Ardleigh Parish Council Response to National Grid Norwich to Tilbury DCO Application

Report on Proposed Route Alignment and EACN Substation Siting in Ardleigh

Revision: 1

Date: 26 January 2026

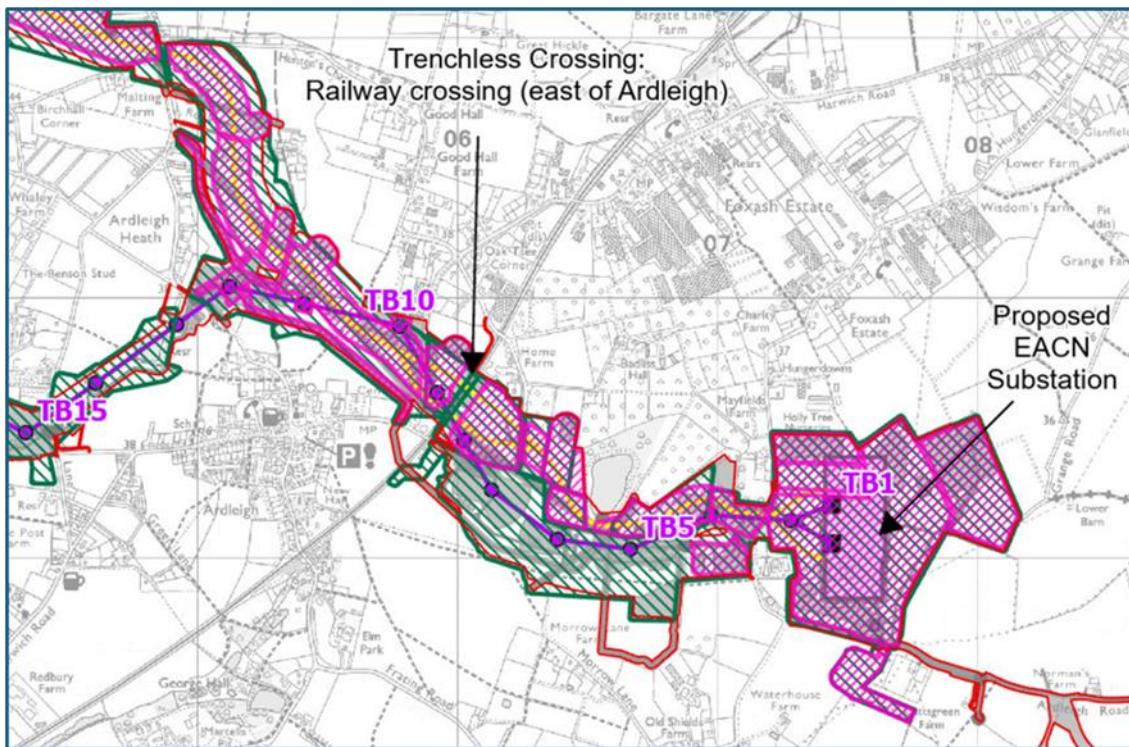
5.24 The proximity of the proposed infrastructure to land immediately to the north of the Scheduled Monument “*Crop mark site S of Ardleigh*” (1002146) is also of great concern in relation to non-designated heritage assets in the area.

At the closest point the proposed Order Limit aligns with the northern boundary of the Scheduled Monument site.

NGET Figure A11.1: Historic Environment Designated and Non-Designated Heritage Assets
Page 13 of 25: Drawing No. 10059280-ARC-ELS-ZZ-DR-ZZ-00188 Rev. A

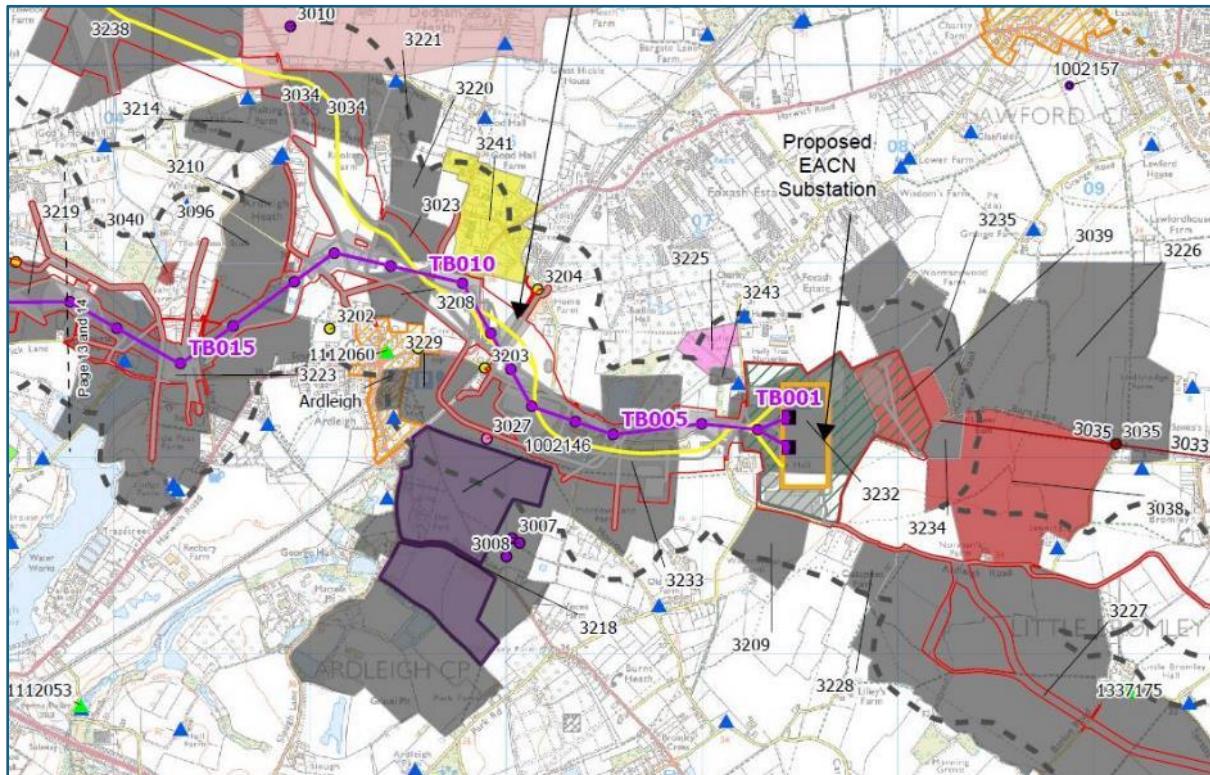
It should be noted that there are 17 listed buildings in the Conservation Area (16 Grade II and 1 Grade II*) and therefore considerably more than shown on this plan.

Similarly, the plan “Norwich to Tilbury - Environmental Constraints - Section C.pdf” shows just 2 of the 17 listed buildings in the Conservation Area (National Grid Drawing Reference: AENC-NG-ENG-PLN-0012, SHEET 11 OF 16, Issue A, Date: APRIL 2024).

NGET Figure A11.1 modified to show Areas A & B, as identified in EAA Report 90 and the additional Roman Roads.

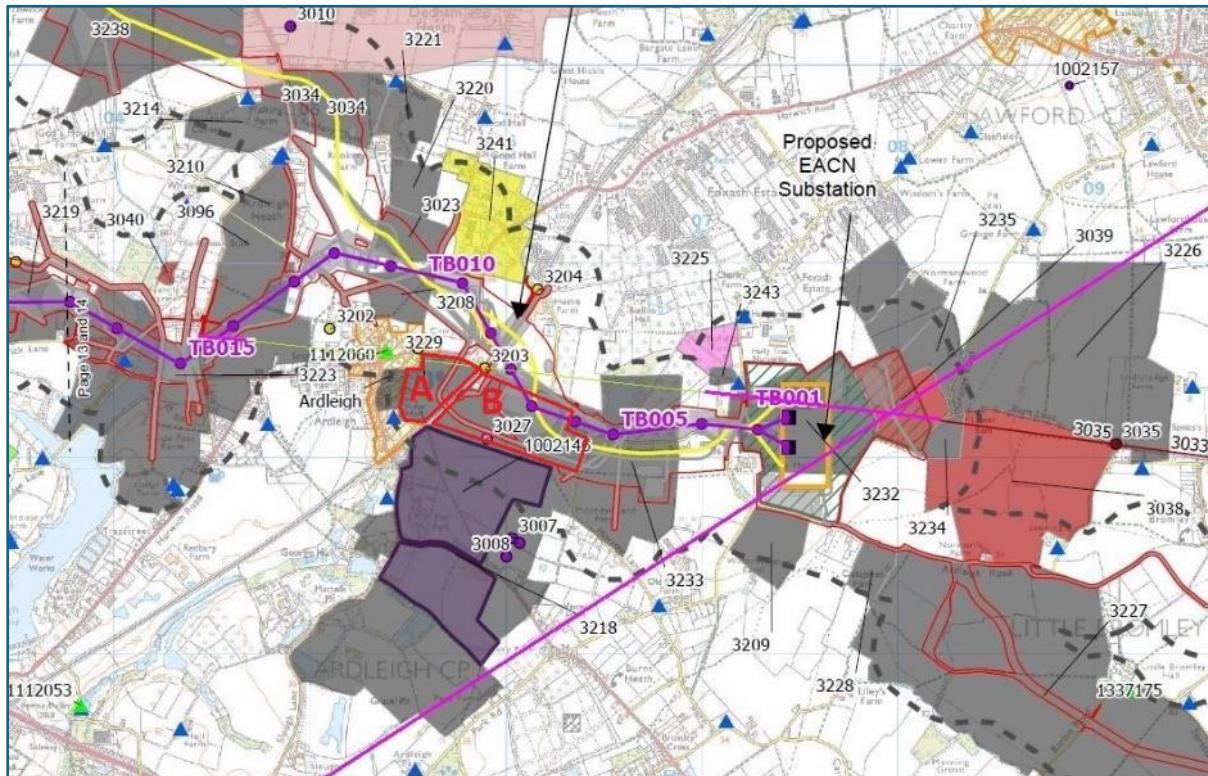
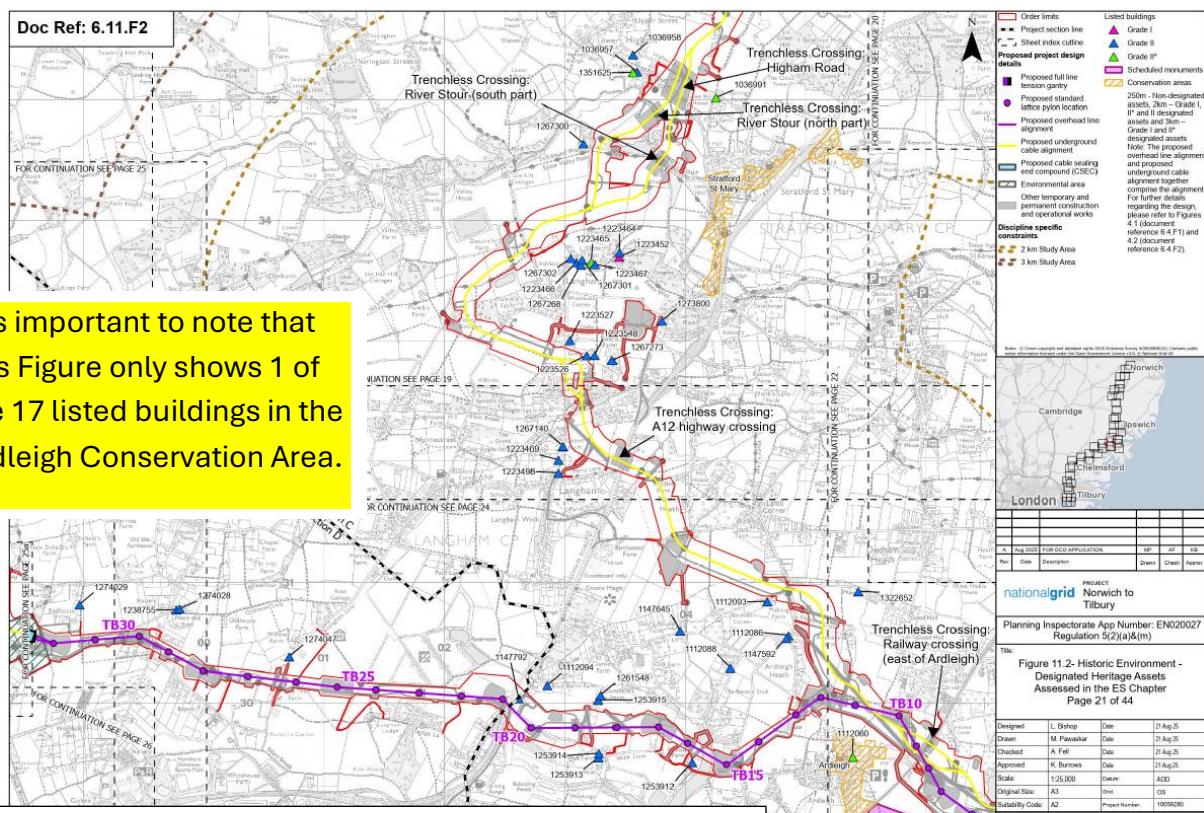
5.9 The non-designated heritage assets map shown in Appendix C-4 also does not consider the additional assets highlighted by Ardleigh PC in its Statutory Consultation submission, as shown in the modified map in Appendix C-2. These are the Areas A & B, as identified in EAA Report 90 and additional information on the Roman Roads 3033/3035 and MEX9020 which intersect the proposed EACN site. (MEX9020 is the reference number used in the EACN Substation Geophysical Survey Report obtained by NGET.)

From: EN020027-000464-6.11.F2 Environmental Statement
Figure 11.2 - Designated Heritage Assets Assessed in the ES
Chapter

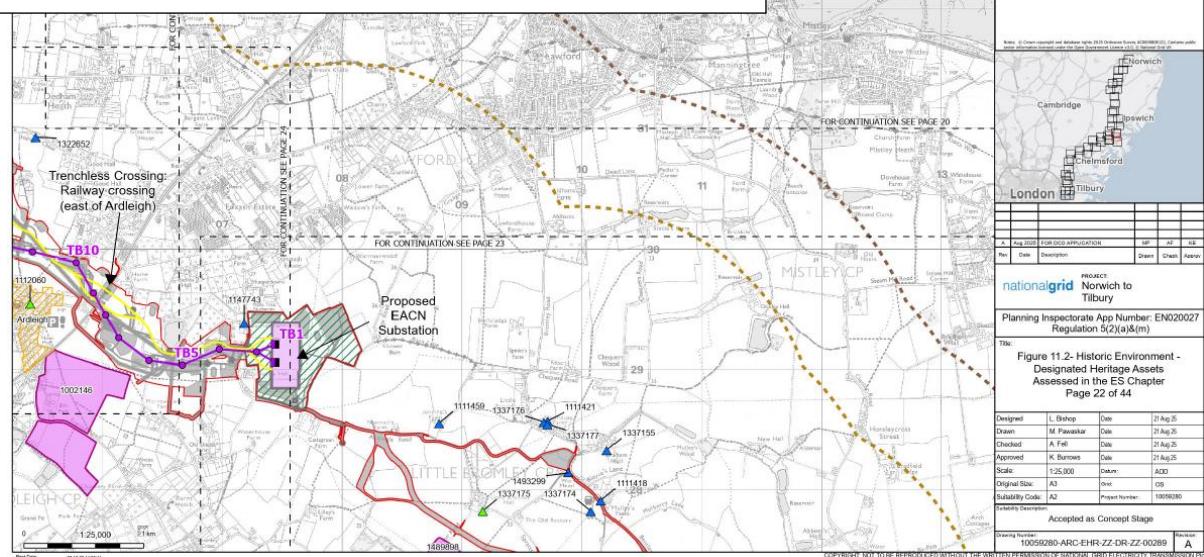
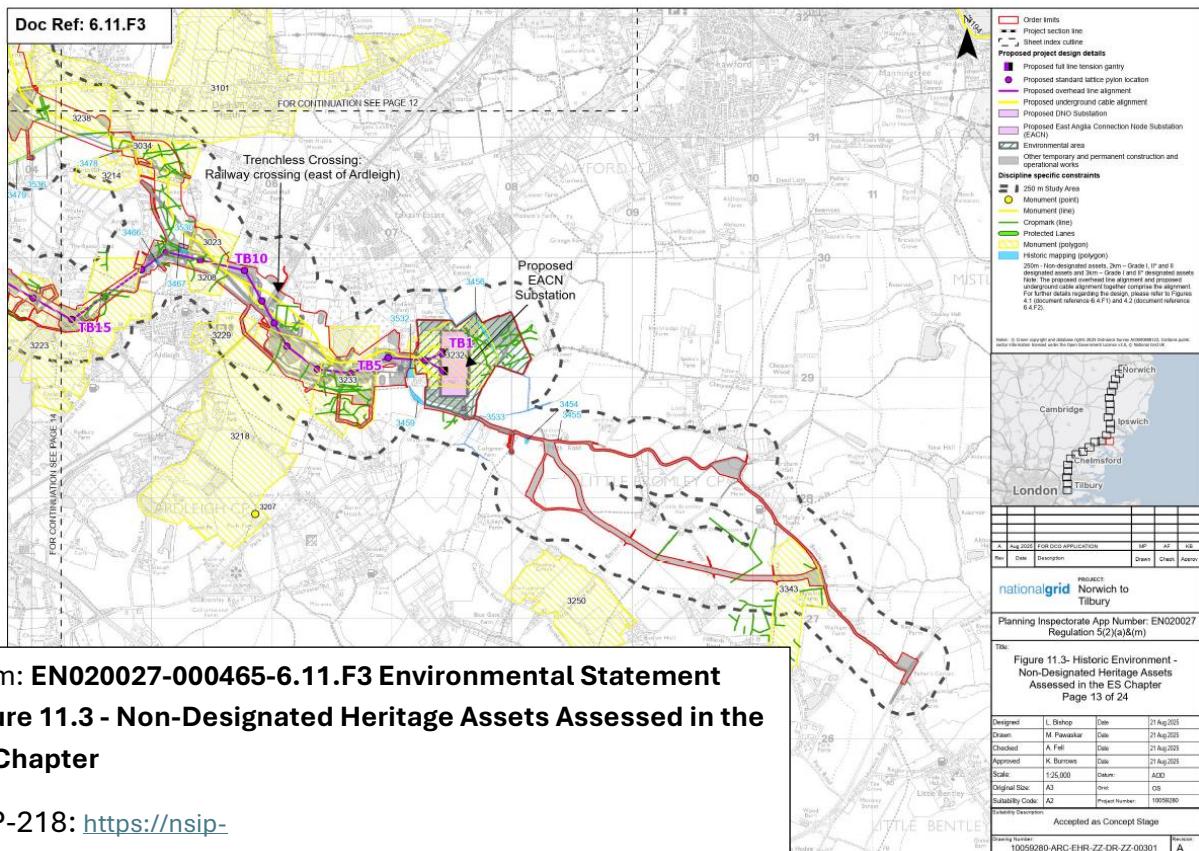
- **17 Listed Buildings out of a total of 71 Listed Buildings in the Parish.** One of these is the Grade II* Church of St Mary (1112060). The remaining 16 are Grade II. *It is important to note that Figure 11.2 in National Grid’s DCO application (APP-217) only shows 1 of the 17 listed buildings in the Ardleigh Conservation Area.*

Increase in length of route and cost due to the currently proposed route diversion

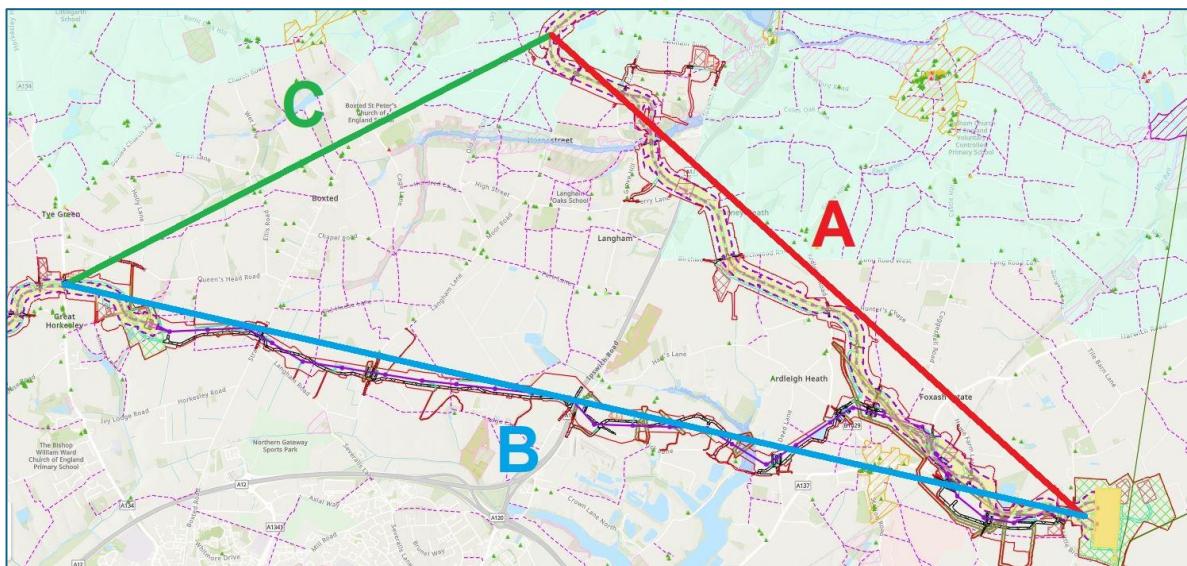
7.8 The calculations, which are presented in Appendix E-1, show that a route diversion into Ardleigh results in an additional Lifetime Power Transfer cost of approximately £154 million, almost doubling the cost of this section of the Norwich to Tilbury route.

7.12 Straight routes were assumed for this comparison with an additional 0.77 km added to “Segment B” in the calculations to account for the length increase resulting from the exceptional serpentine OHL route proposed around Ardleigh village centre between TB3 and TB21. This increase in length alone results in an additional cost of £5.5 million, as established from the calculations in Appendix E-1 (using the 2025 IET figures). The additional cost is likely to be substantially higher than this due to the excessive number of angle towers required. The previous version of the IET report²¹ discusses how the cost increases significantly in such situations.

Straight routes were assumed for this comparison but with an additional 0.77 km added to Segment B to account for the length increase resulting from the exceptional OHL deviation around Ardleigh village centre between TB3 and TB21. This alone results in an additional cost of £5.5 million.

Appendix G-1: Alignment of towers TB-1 to TB-21

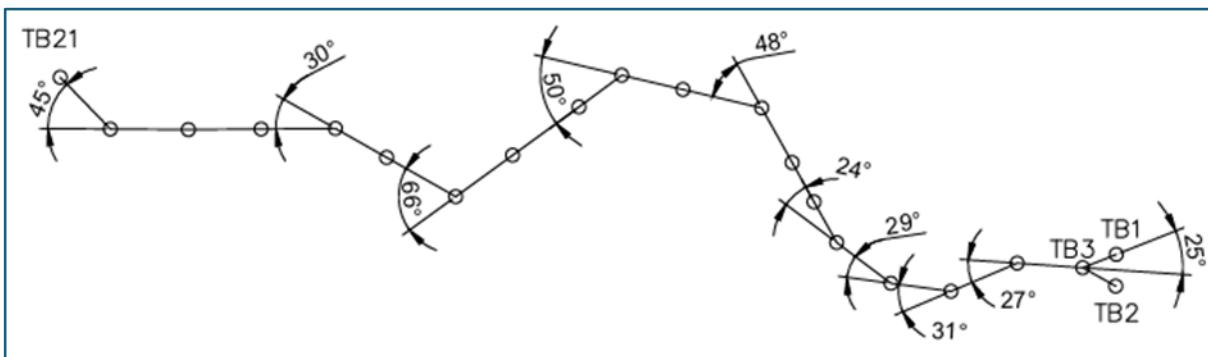
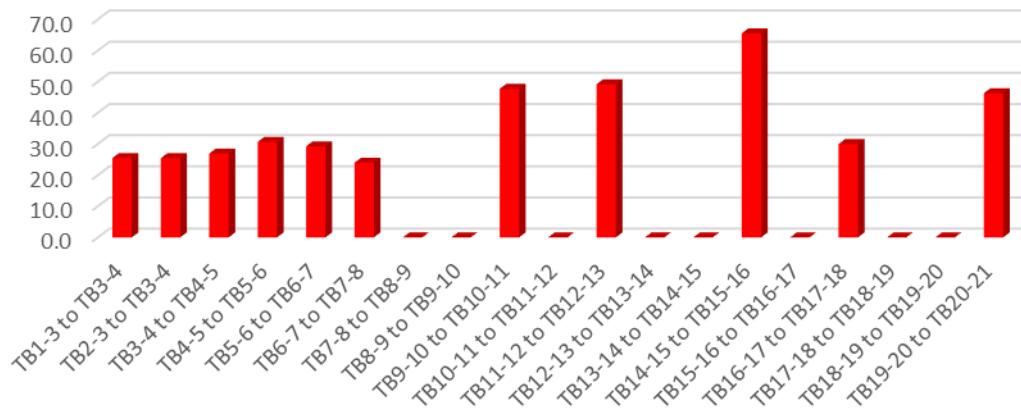
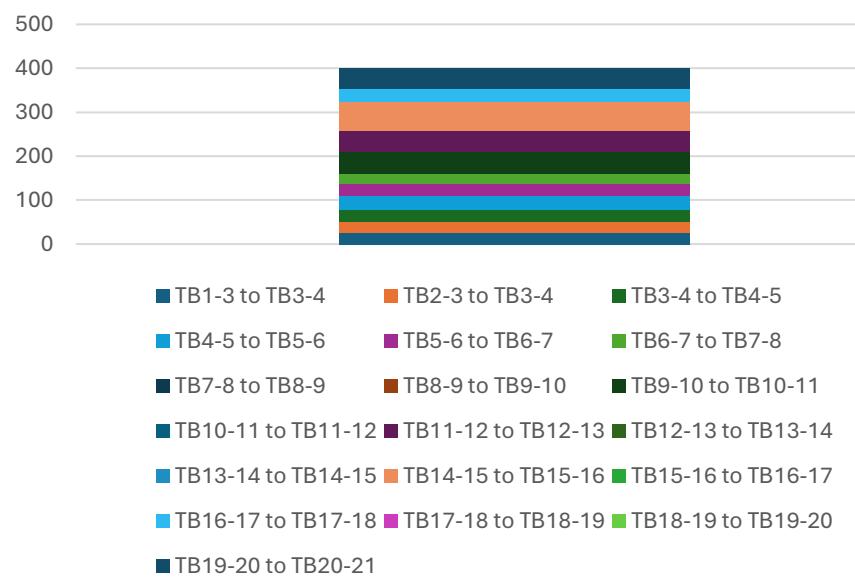
7.24 A detailed assessment was made of the changes in direction in the current plans, starting from TB1 and TB2 on the proposed EACN site and ending at TB21. TB21 is located outside the Parish boundary, but as it is only approximately 75m from the boundary it would therefore be very visible from within the Parish.

7.25 The calculations show that between TB1 and TB21 the average difference in alignment from one cable span to another is approximately 21° . Four of the spans are at an angle greater than 45° and one of these is at an angle of 65° . The greater the misalignment of each span, the more visually intrusive the angle pylons become due to increase in the length of the cross arms and the greater asymmetry.

7.26 The total cumulative misalignment in this section is approximately 400° . This therefore represents an overall change in alignment equivalent to more than a full circular rotation, and this occurs within a linear distance of only 5km between the start and end points. The calculations and the charts presenting the results are provided in Appendix G-1.

Appendix H-1: Alternative North Falls and Five Estuaries Connection Options

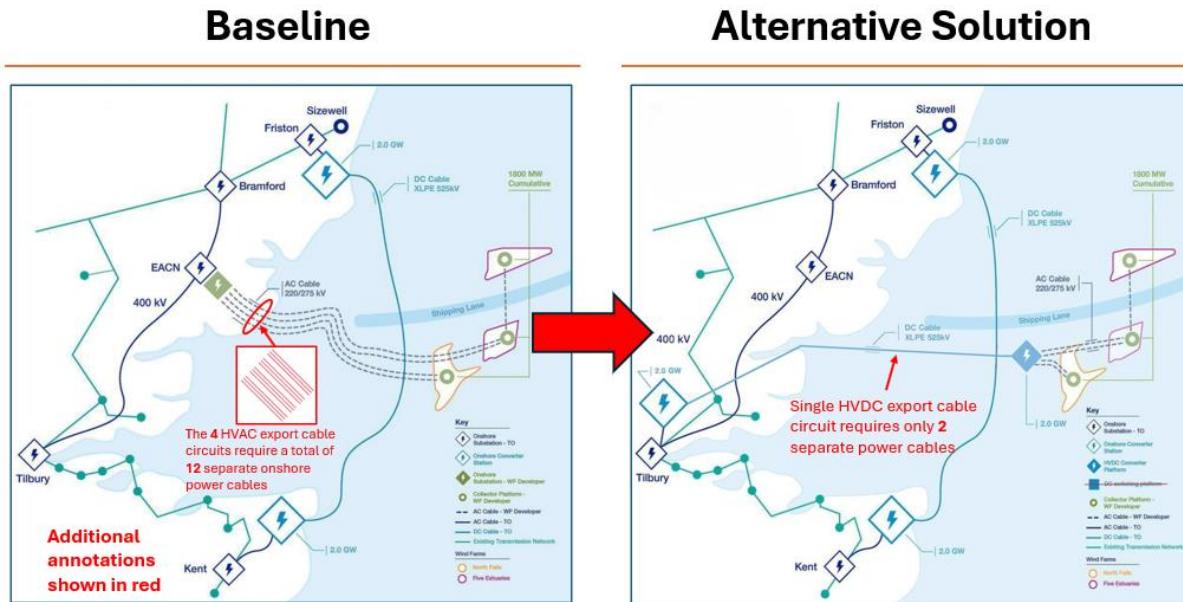
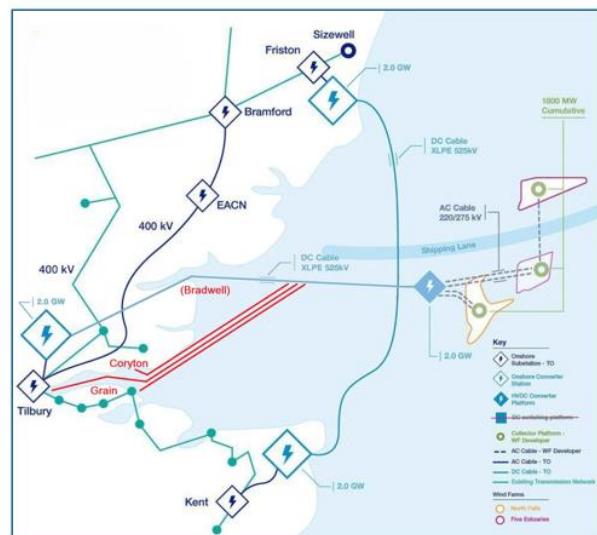
- There could be any number of variants of the “Alternative Solution”.
- The red lines and text added to the figure on the right are to illustrate other land fall points that could be explored.
- The aim is to minimise overall harm. For example, brownfield sites should be prioritised for the location of converters and substations.
